PRODUCT CHANGE NOTIFICATION (PCN)

AMJE0909-0500-RDB-24
MODULAR CABLE

CHANGE NOTIFICATION: PCN 20220509_AMJE0909-0500-RDB-24

DESCRIPTION OF CHANGES:
CHANGE OF DATA SHEET
CHANGE OF DATA SHEET
New Draw.-No. ASS_7945_CArev02

AMJE0909-0500-RDB-24 OLD VERSION

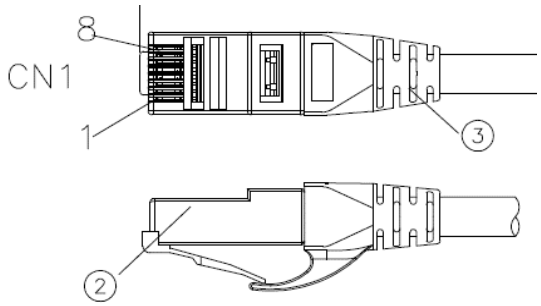
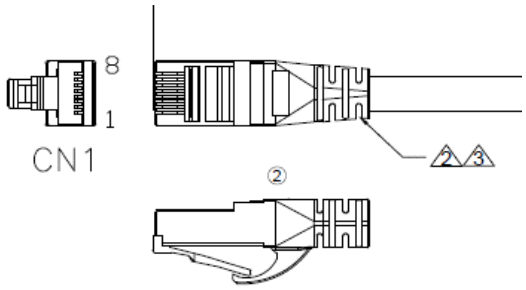
REASON FOR CHANGE:
CHANGE OF PRODUCT LOCATION
CHANGE OF PRODUCT LOCATION

③	Molding	PVC 45P Color: see order code	NA	KG
②	CONNECTOR	RJ45 8P8C two fork Short type 3u" gold plated	2	PCS
①	CABLE	CAT6 UTP (24AWG*1PR)*4+PVC OD=5.8±0.3MM Color: see order code	NA	MM
NO:	NAME	DESCRIPTION	Q'TY	UNIT

3	Molding	PVC 65P Color: see order code ②	NA	KG
2	CONNECTOR	RJ45 8P8C PLUG 3u" gold plated ②	2	PCS
1	CABLE	CAT6 U/UTP (24AWG*1PR)*4+Cross+PVC Jacket OD=5.8± 0.3MM Color: see order code ②	NA	MM
NO:	NAME	DESCRIPTION	Q'TY	UNIT

Drawing-No.
ASS 7945 CA

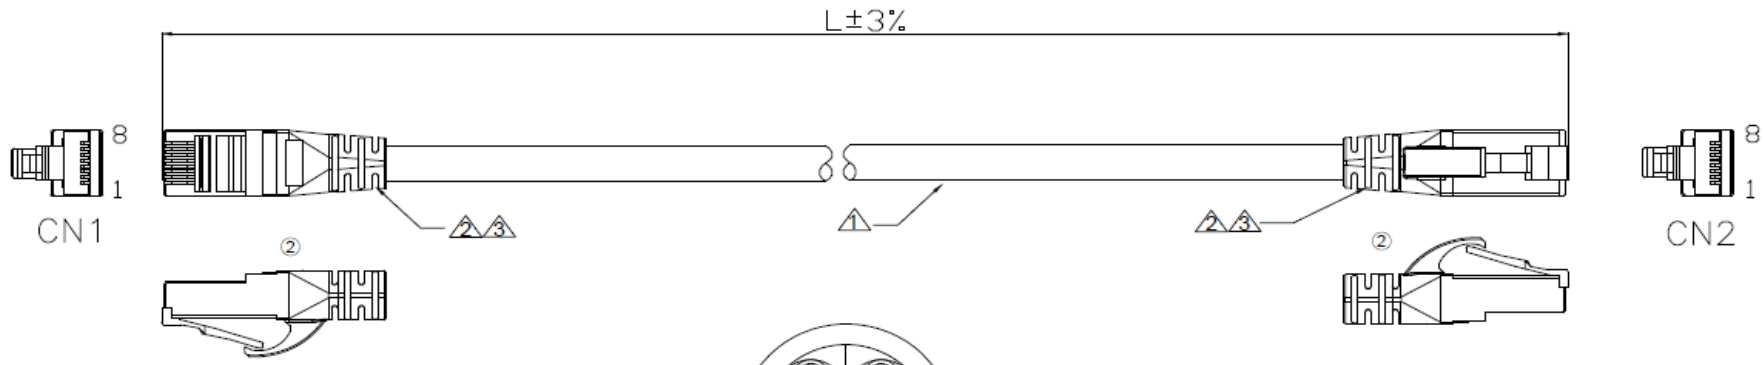
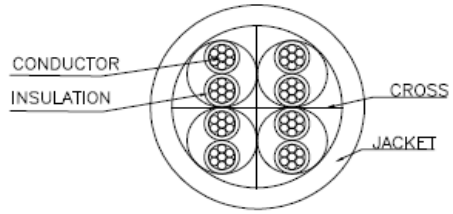
Id.	Modification	Date	Name
②	Change the plant	09.05.2022	Luca
①	Update the WSW order code	02.06.2017	Amy
⓪	Drawn	30.03.2017	Amy

NO:	NAME	DESCRIPTION	Q'TY	UNIT
3	Molding	PVC 65P Color: see order code ②	NA	KG
2	CONNECTOR	RJ45 8P8C PLUG 3u" gold plated ②	2	PCS
1	CABLE	CAT6 U/UTP (24AWG*1PR)*4+Cross+PVC Jacket OD=5.8± 0.3MM Color: see order code ②	NA	MM
